Project Name:	Coldharbour Farm Road, Emsworth
Document Reference:	187.0018/TN/1
Document Name:	Transport Note
Prepared By:	Mark Smith (May 2026)
Checked By:	Mark Smith (May 2026)
Approved By:	Mark Smith (May 2026)

TECHNICAL RESPONSE TO HCC HIGHWAYS COMMENTS

Road Safety Audit Report

Proposed Continuation of Coldharbour Farm Road Emsworth

SCALE: AS SHOWN @ A1 DATE: 15.11.2023

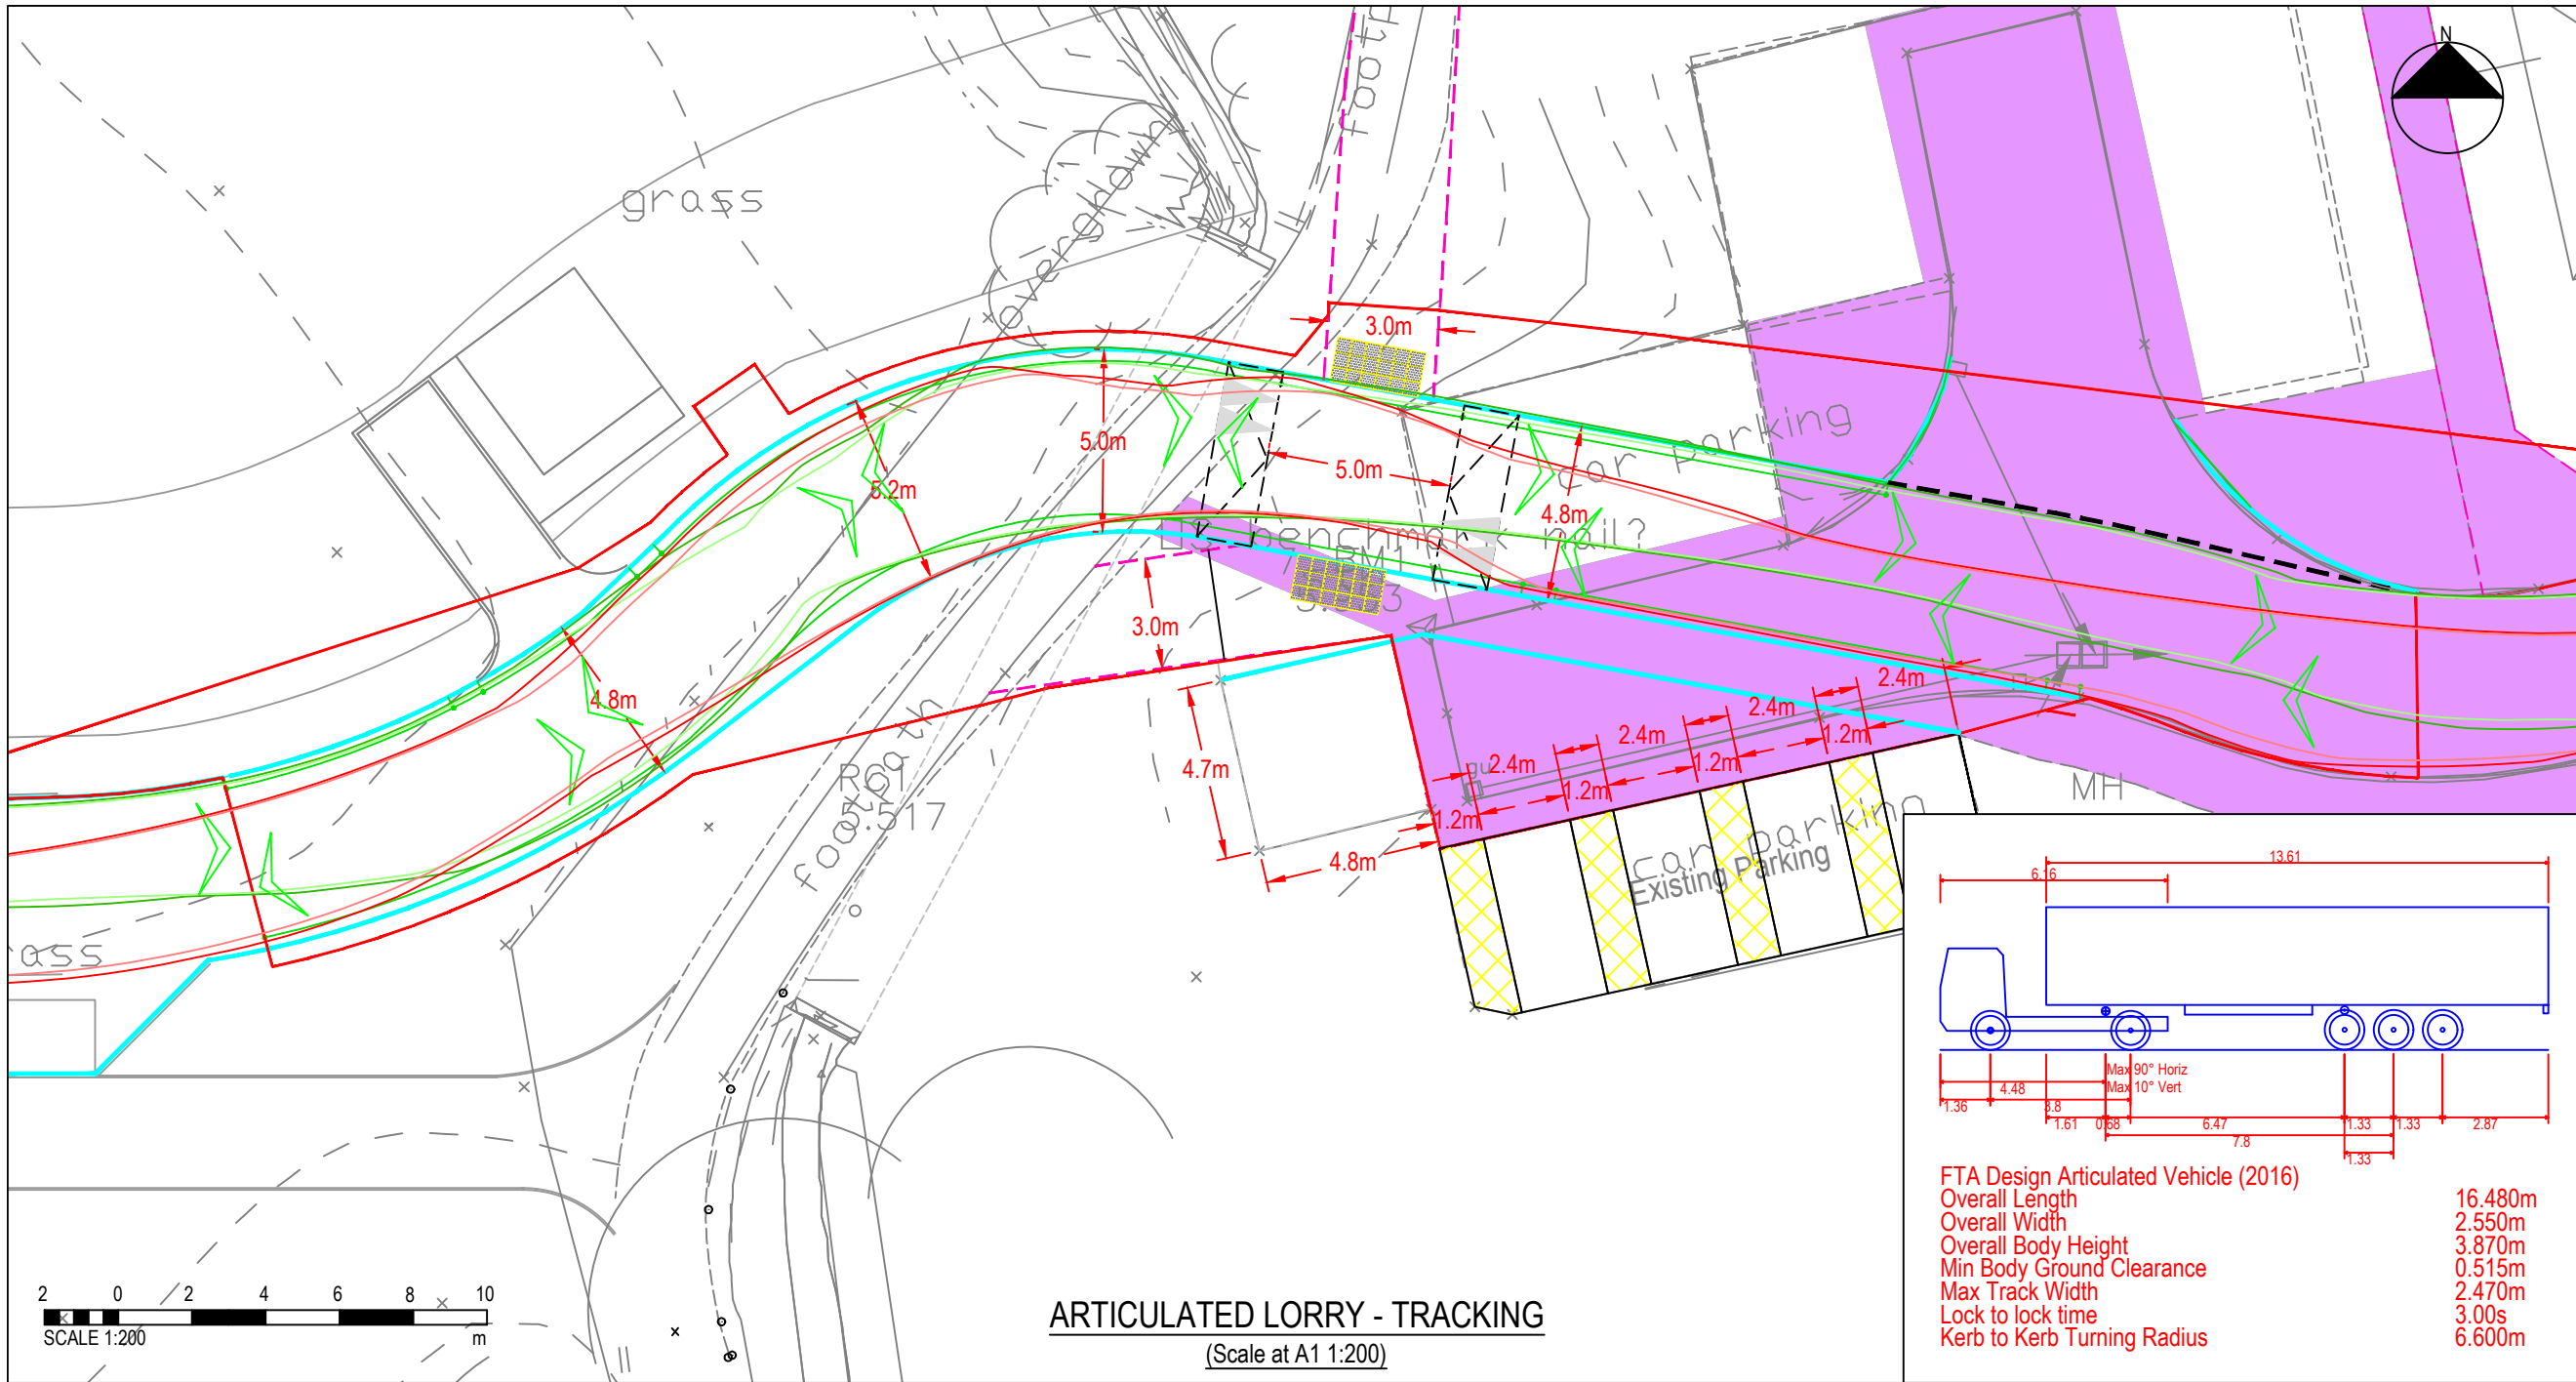
B2.2 Vehicles may not be able to access the existing parking bays. It is recommended that the bays are accessible.

B.4.1 - Cyclists are likely to continue without giving way to traffic. It is recommended that an appropriate level of visibility is achievable.

B.4.2 - Non-motorised users at and on approach to the uncontrolled crossing may not be clearly visible during the hours of darkness. It is recommended that visibility is achievable to the tangent and that the proposed crossing point is illuminated adequately with a column provided immediately to the west of the crossing point as previously proposed.

The existing parking bays are proposed to be relined as shown on Drawing 23339-JUBB-XX-XX-DR-X-000100 REV C13 and the tracking is shown on Drawing 23339-JUBB-XX-XX-DR-X-001203 REV C1.

Suitable visibility splays for cyclists are as shown on Drawing 23339-JUBB-XX-XX-DR-X-000100 REV C13. In dashed orange. With regards to lighting, this has been confirmed as suitable by the lighting designer.

Suitable visibility splays for pedestrians are as shown on Drawing 23339-JUBB-XX-XX-DR-X-000100 REV C13. In dashed yellow. With regards to lighting, this has been confirmed as suitable by the lighting designer.
